## 940 Edison Garage & Shed Project - Revised

There are already approvals in place for the shed as well as replacement of the garage doors, and for the garage rehabilitation project. This is a submission to account for changes and requirements made by BSEED to bring the structure as close to code as possible.

Figure 1 8x8 Carriage doors proposed.

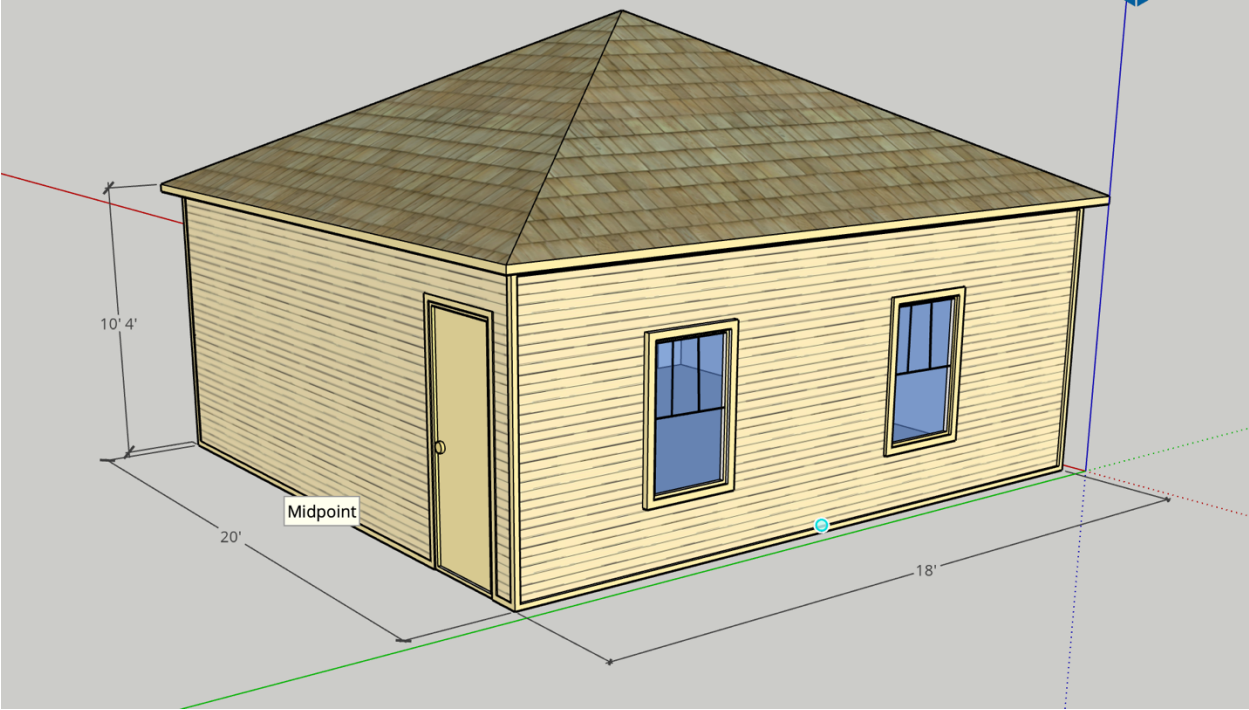
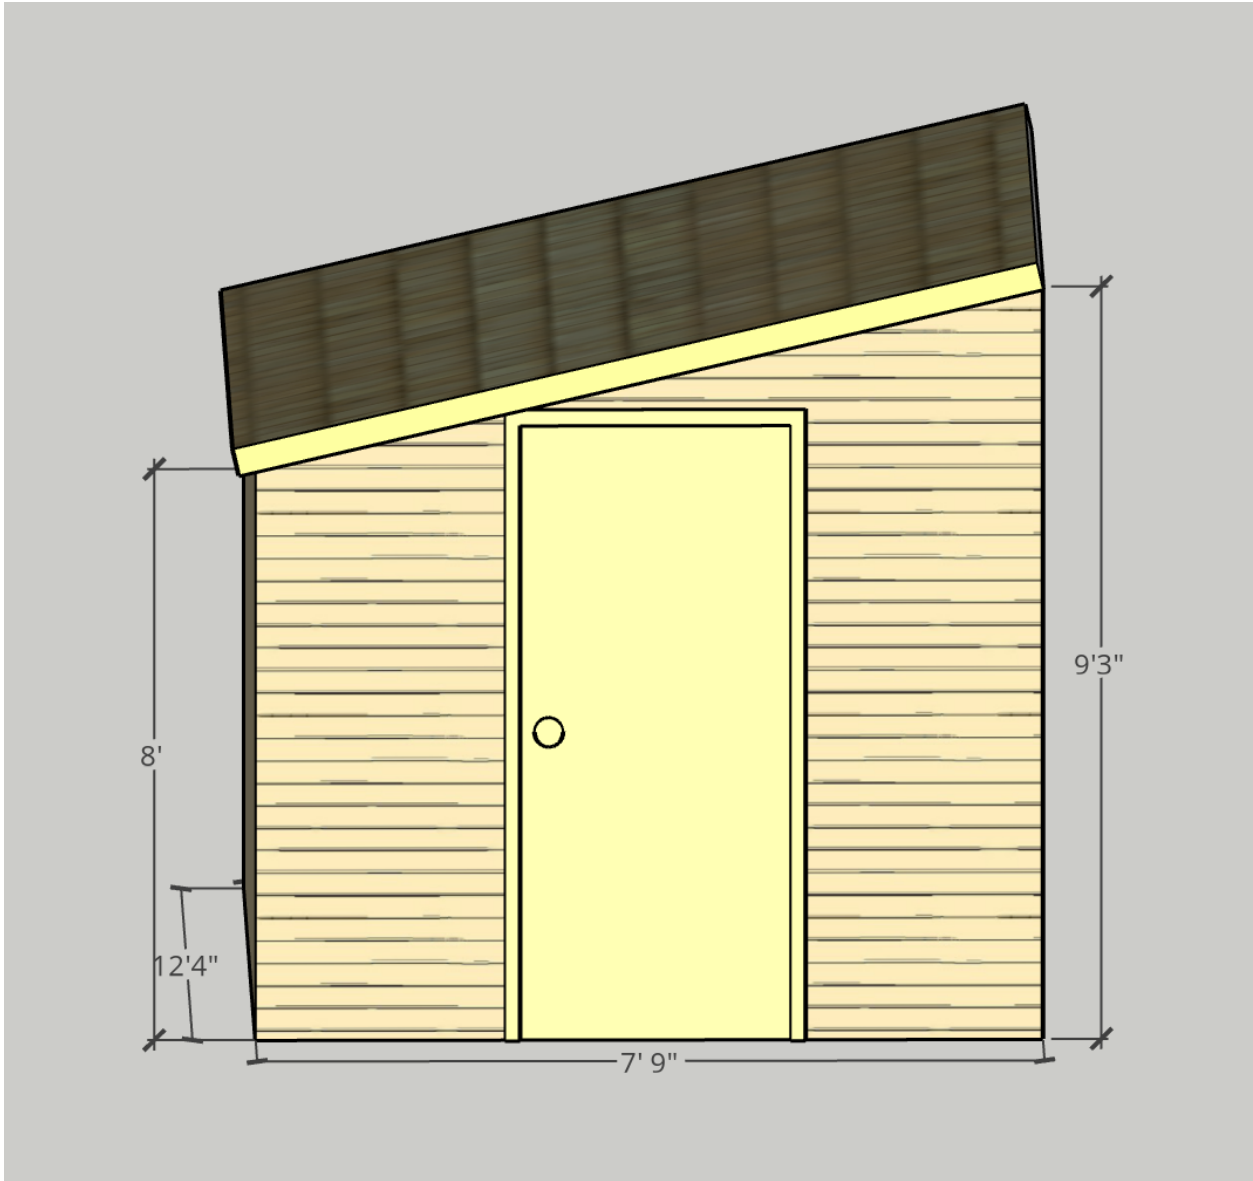
-Requirement of 18" header above garage doors, per code, instead of a 6" header. This requirement makes it impossible to install 7' or 8' doors without making the garage taller. My solution was to set the garage down with 10' 2x4's, thus leaving room for 8' doors below the header. BSEED would like confirmation from historic that 10' in height is approved.

- Obtain approval from HDC to allow for increased garage height (10') to accommodate increased header and doors as required by HDC.
- Obtain approval from HCD to allow fire-suppressant material on the East side of the garage. The rest of garage will use the original wood german-lap style siding.
- Obtain approval to modify the height of the lean-to shed to be proportional with increased garage height. 8'1" to 9'3" will be the roof pitch, tucking under the garage soffit with about 6" of siding exposed.
